ENGINE - REVISED CLIPPING AT CP5737 AND THE CLIPPING BRACKET MODIFICATION - CATEGORY
CODE 4 - MOD.ENG-72-0039

V2500-ENG-72-0039

SERVICE BULLETIN

Location of the clipping position CP5737 and the clipping bracket
Fig.1

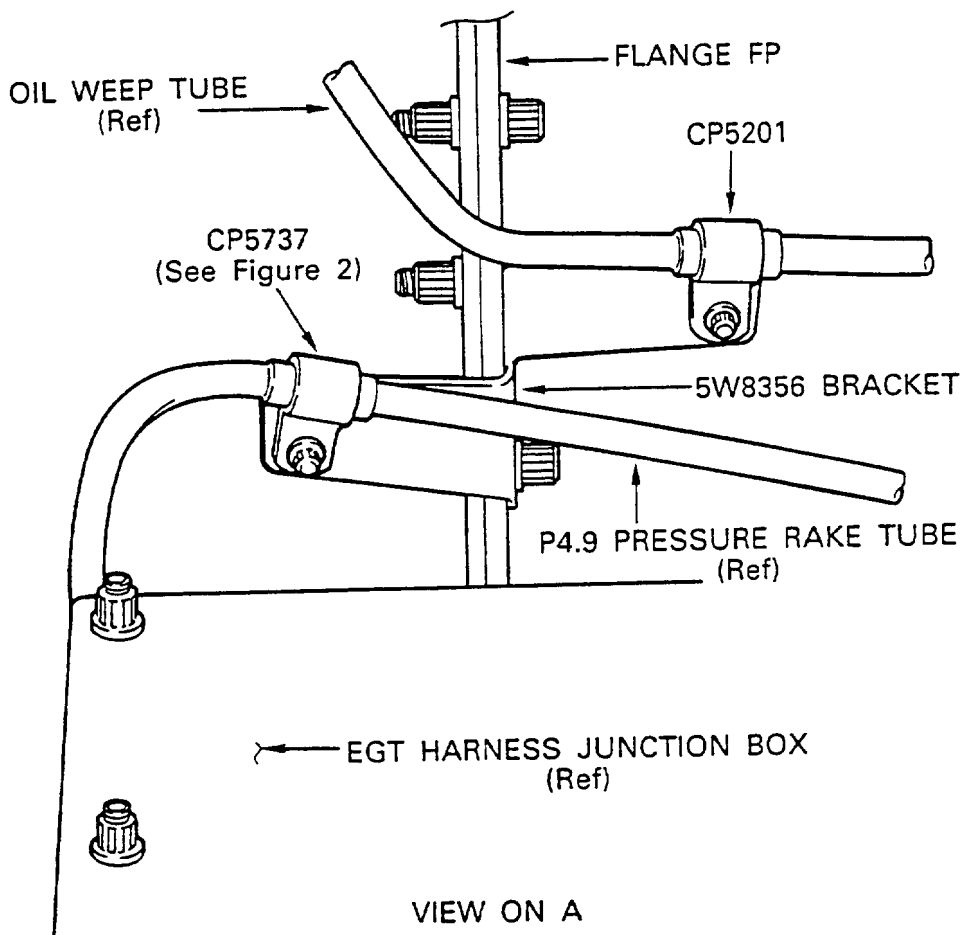
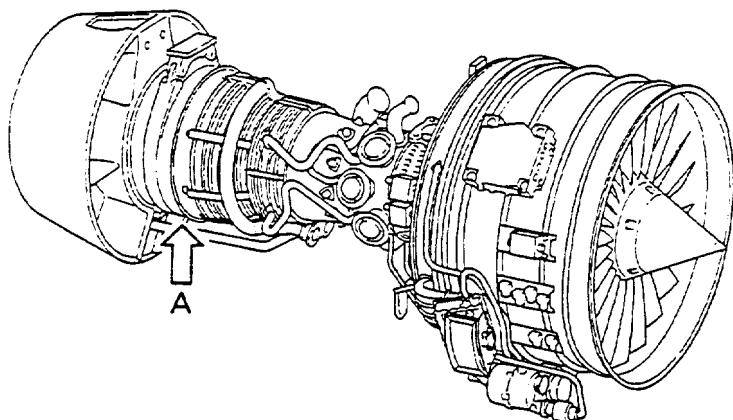
(a) The existing CP5737 which safties the P4.9 Pressure Rake Tube and the clipping Bracket has been rearranged to reroute the tube. (See Figures 1 and 2).

- (1) Find PN 5W8356, Clipping Bracket, which is used for the clipping position CP5201 and CP5737. (Refer to Figure 1).
- (2) At CP5737, remove PN 4W0102, Bolt, PN 5W1086, Washer, PN 5W1109, Clip, and PN 4W0043, Clip Nut, from the P4.9 Pressure Rake Tube and PN 5W8356, Clipping Bracket. (Refer to Figures 1 and 2).

Clipping detail at clipping position CP5737 - Before and after alteration
Fig.2

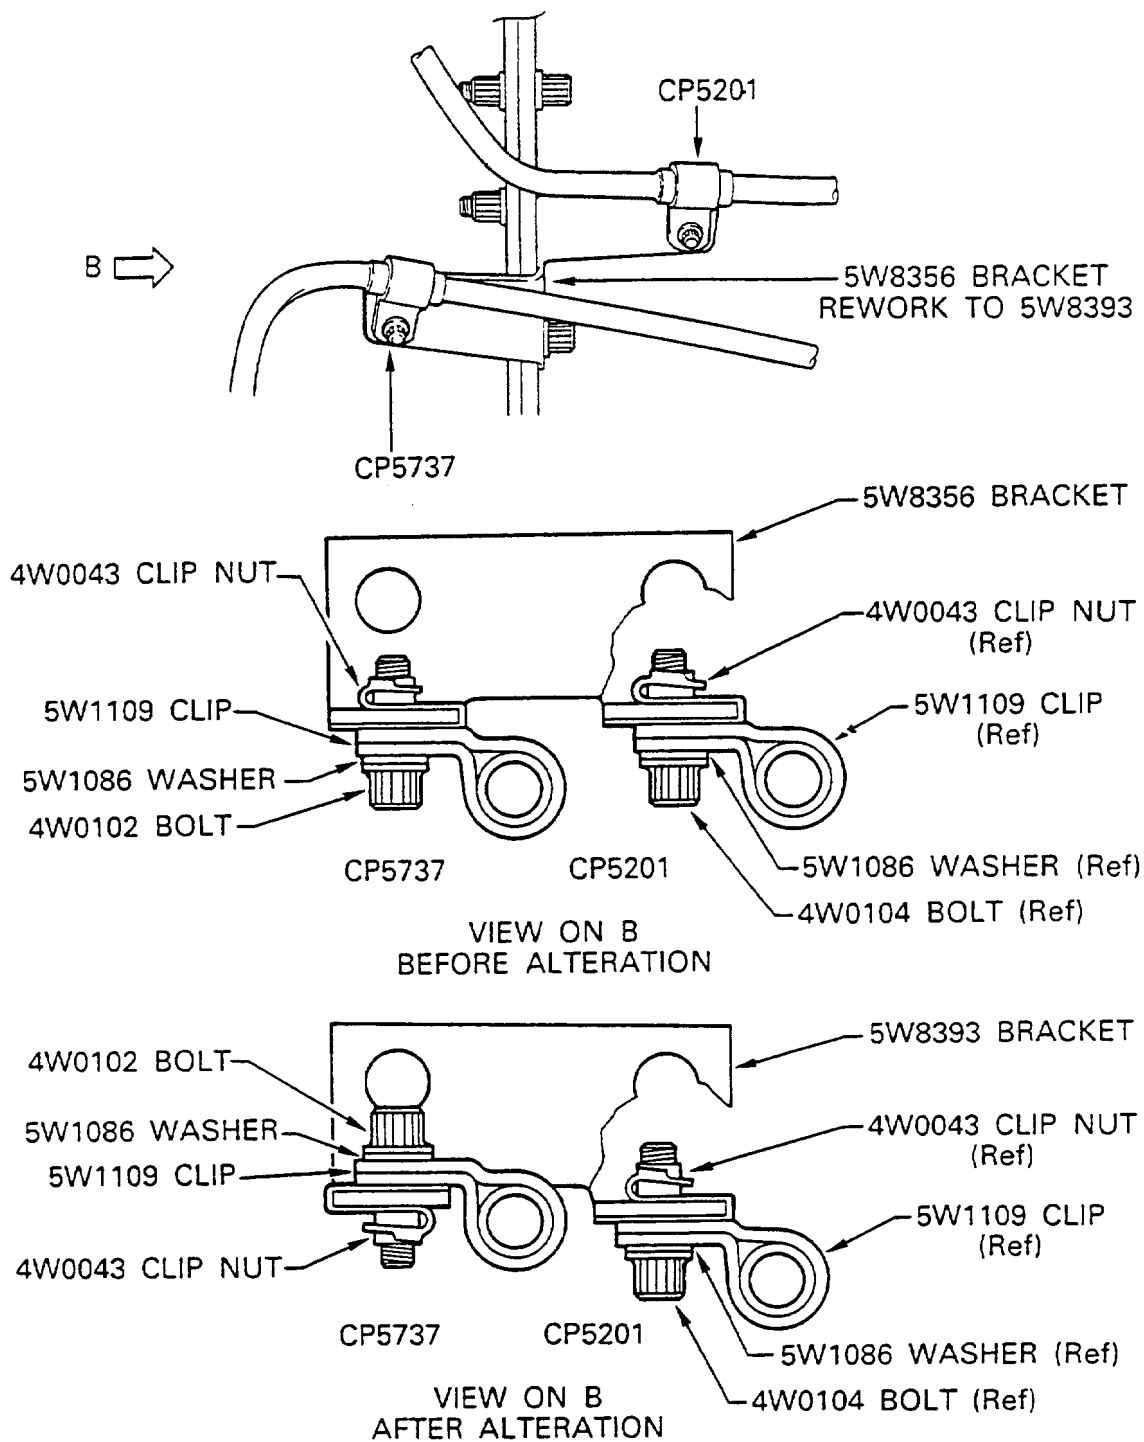
A foul occurs between the P4.9 Pressure Rake Tube (Fuel System Air Tube) and the RH side C-Duct Hold Open Rod when the RH side Hold Open Rod is in a stowed position.

The contact area is where tube run changes from axial to circumferential above the EGT Harness Junction Box, with the top rear edge of the stowed Hold Open Rod.

An examination has shown that unsatisfactory clipping and bracket arrangement at CP5737 can cause the P4.9 Pressure Rake Tube to contact the RH C-Duct Hold Open Rod.

Rework of the clipping bracket
Fig.3

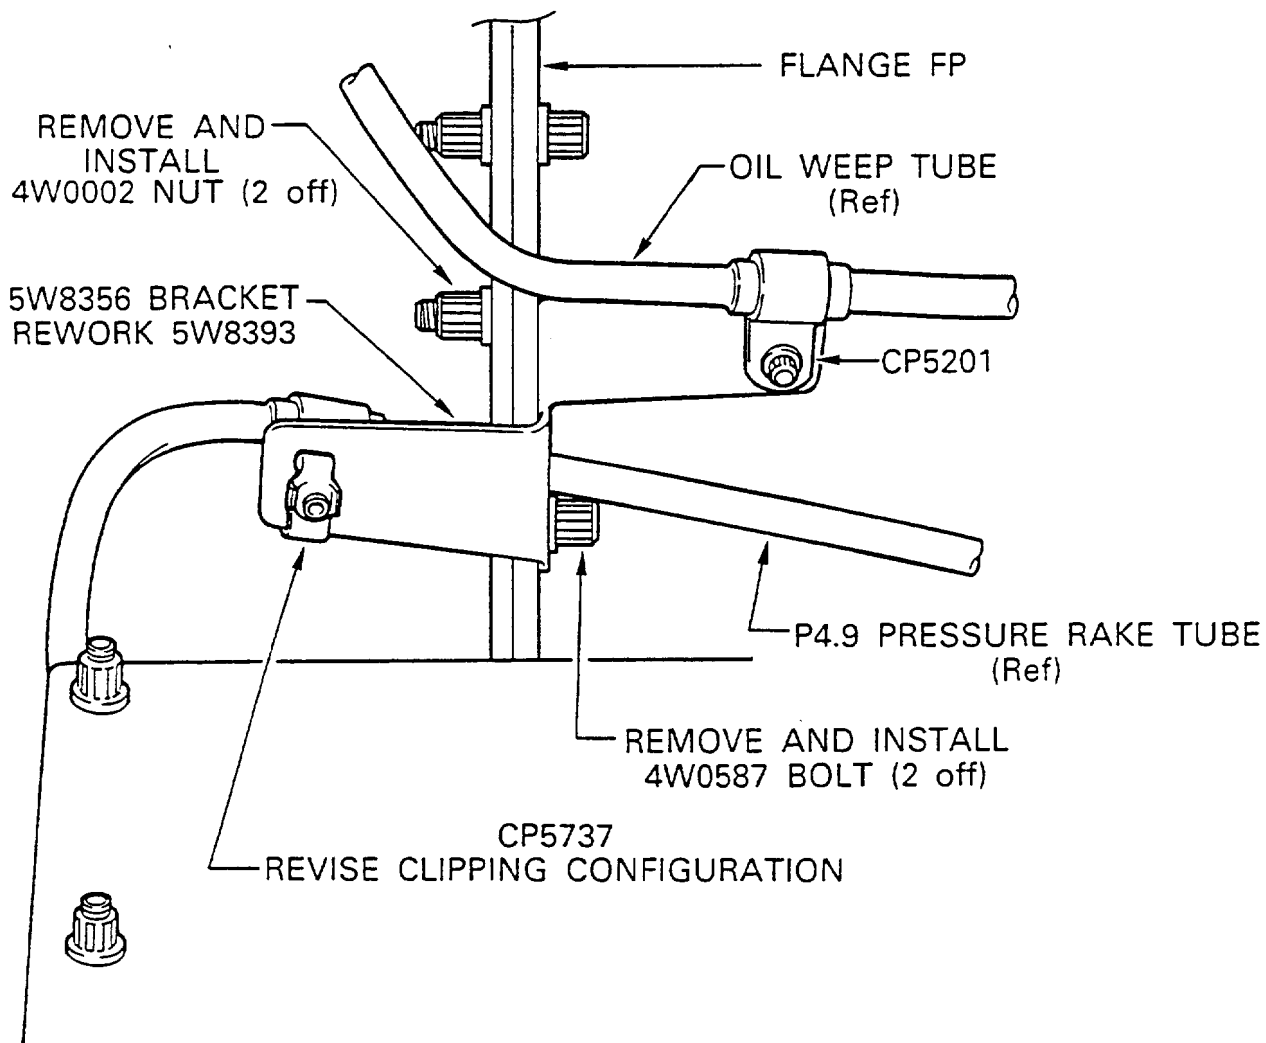
(b) The existing clipping Bracket PN 5W8356 is modified to prevent a foul to the rerouted P4.9 Pressure Rake Tube. (See Figure 3).

- (4) Remove the two PN 4W0002, Nuts, and two PN 4W0587, Bolts, which attach PN 5W8356, Clipping Bracket, to the Flange FP. (Refer to Figure 3, Sheet 1).

- (9) Attach the reworked PN 5W8393, Clipping Bracket; with two PN 4W0587, Bolts, and two PN 4W0002, Nuts, to the FP Flange. (Refer to Figure 3, Sheet 1).

- (10) Tighten two PN4W0002 Nuts, on two PN 4W0587, Bolts, with a torque of 85-95 lbfin (9,6-10,7 Nm). (Refer to Figure 3, Sheet 1 and the Aircraft Maintenance Manual, 70-23-11, Torque Tightening Technique).
- (11) At CP5201, attach PN 4W0043, Clip Nut, PN 5W1109, Clip, PN 4W0104, Bolt, and PN 5W1086, Washer, to PN 5W8393, Clipping Bracket, and the Oil Weep Tube. Tighten PN 4W0104, Bolt with a torque of 36-40 lbfin (4,07-4,52 Nm). (Refer to Figure 2 and the Aircraft Maintenance Manual, 70-23-11, Torque Tightening Technique).
- (12) At CP5737 with a new clipping configuration, attach PN 4W0043, Clip Nut, PN 5W1109, Clip, PN 4W0102, Bolt, and PN 5W1086, Washer, to PN 5W8393, Clipping Bracket, and the P4.9 Pressure Rake Tube. Tighten PN 4W0102, Bolt with a torque of 36-40 lbfin (4,07-4,52 Nm). (Refer to Figure 2 and the Aircraft Maintenance Manual, 70-23-11, Torque Tightening Technique).

Rework of the clipping bracket
Fig.3 (Sheet 2 of 2)

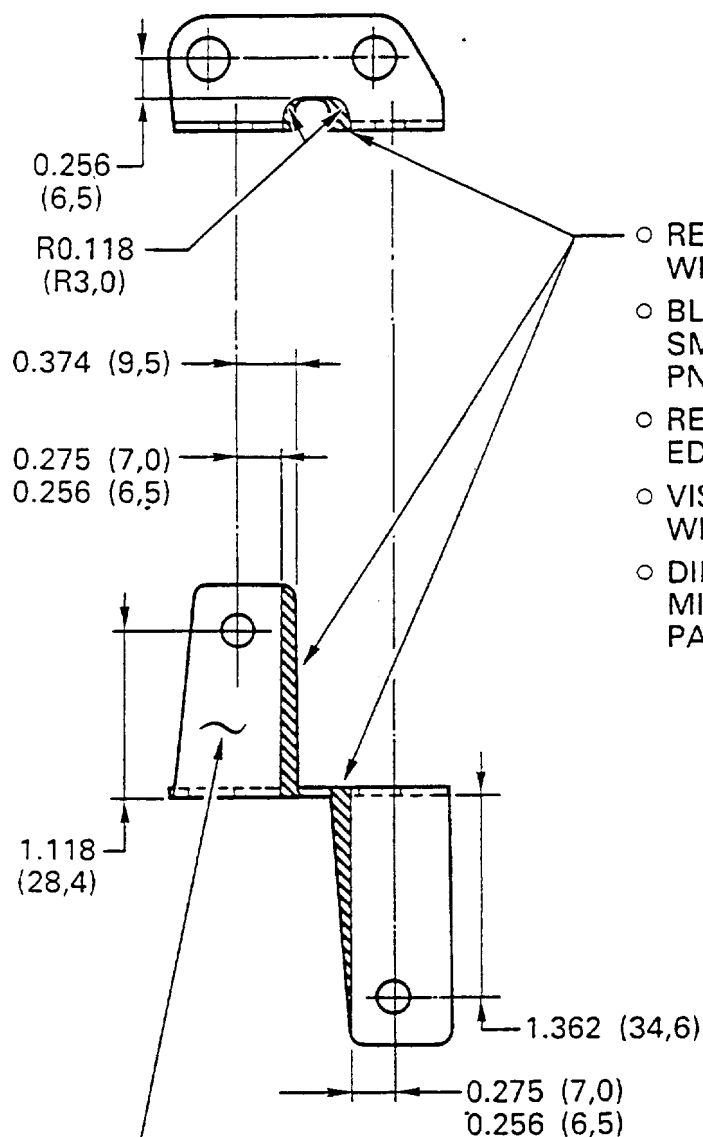
- (5) Remove PN 5W8356, Clipping Bracket, from the Flange FP.
- (6) Remove the inner contours of PN 5W8356, Clipping Bracket, with a File. (Refer to Figure 3, Sheet 2).

- (7) Blend the removed contours smoothly and remove all the sharp edges and burrs with a Hand held Pneumatic Grinder. (Refer to Figure 3, Sheet 2 and the Facilities Equipment Manual, Identification No. RB010).

- REMOVE THE HATCHED PORTIONS WITH A FILE.
- BLEND THE REMOVED CONTOURS SMOOTHLY WITH A HAND HELD PNEUMATIC GRINDER.
- REMOVE BURRS AND BREAK SHARP EDGES 0.002 (0,05) TO 0.019 (0,5).
- VISUALLY INSPECT THE SURFACES WHICH NO CRACKS ALLOWED.
- DIMENSIONS ARE IN INCH WITH MILLIMETERS CONVERSIONS IN PARENTHESES.

USE VIBRO-PEEN TO IDENTIFY NEW PN 5W8393 ADJACENT TO EXISTING PN 5W8356 IDENTIFIED HERE.
MARK TWO LINES (=====) ON EXISTING PN WITH VIBRO-PEEN TO ERASE IT.
